Report to	Norwich Highways Agency Committee 22 May 2008	Item
Report of	Head of Transportation and Landscape	8
Subject	Tourist Vehicles in The City Centre

To inform members of representations made to the advertised Traffic Regulation Order for the proposed Road Train stop on St Peters Street in order to facilitate a decision.

Location plan for proposed Road Train stop submitted for the advertised TRO

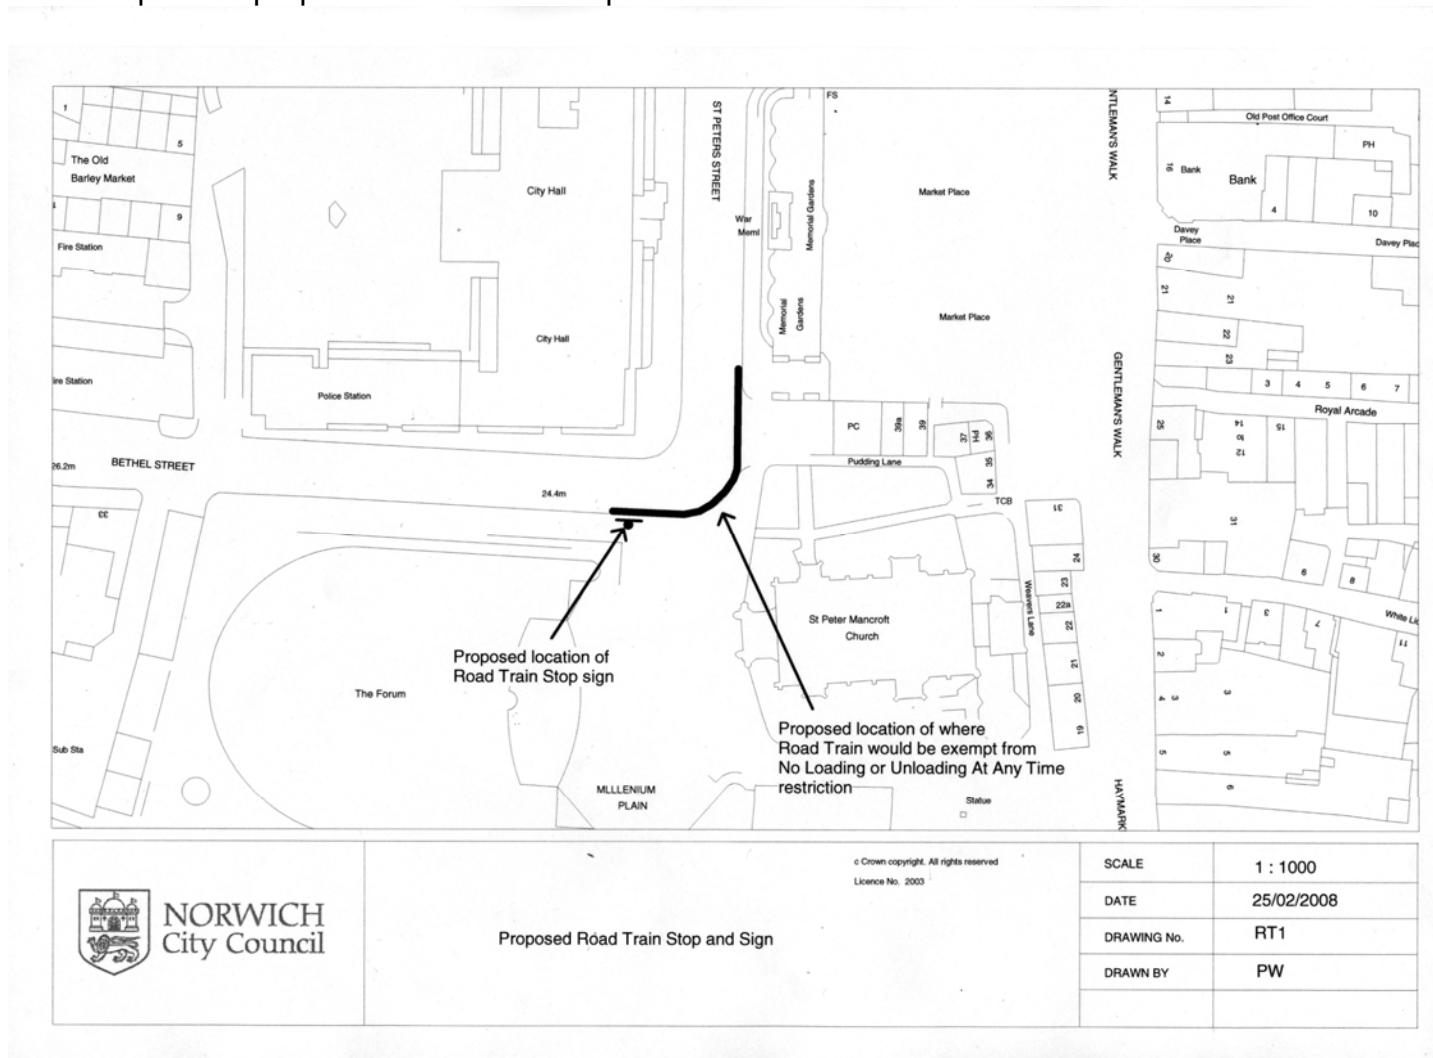
- 1) Potential hazard posed to traffic using St Peters Street/Bethel Street.

Despite the off road parking location, the positioning of the Road Train stop on a bend means that the manoeuvre is unlikely to be successful on every occasion. There is a risk that traffic approaching from Guildhall may need to avoid the rear of the Road Train and face oncoming traffic, some of which may be emergency vehicles on “blue light” calls, given the proximity of both the Fire and Police Stations.

- 2) Potential obstruction to pedestrian and pedal cycle desire lines to and from Millennium Plain.

Recent works to improve St Peters Street have resulted in significant enhancements to pavement widths and informal crossings provided by “tables”. The location of the proposed Road Train stop would be exactly across these desire lines and would necessitate pedestrians and cyclists making detours around the vehicle. This is an unreasonable inconvenience and is the reason why at present there are extensive no loading and no waiting restrictions at this location to keep it free of parked vehicles to facilitate pedestrian and cycle priority.

- 3) Restricted access to Millennium Plain and St Peter Mancroft via St Peter Street/Multiple tourist operators wishing to use proposed stop location.

Both St Peter Mancroft and Millennium Plain require full unimpeded access

to facilitate their operation for a number of different purposes. This is a particular concern if waiting times were increased from the proposed 10 minutes, to 15 minutes, as requested. Whilst the any tourist vehicle could be asked to move if required, the likelihood of other tourist operators wishing to use this stop could result in unacceptable levels of usage and congestion at this location. It should also be noted that often articulated vehicles are used to service events on Millennium plane, and if these had to wait on the carriageway in St Peters Street for the road train to move this would cause considerable congestion on what is one of the main access routes to the fire station.

- (1) not to introduce a stop for the road train on the corner of St Peters Street and Bethel Street;
- (2) not to allow the Sightseeing Tour of Olde Norwich vehicle to be exempted from any further pedestrianisation restrictions.
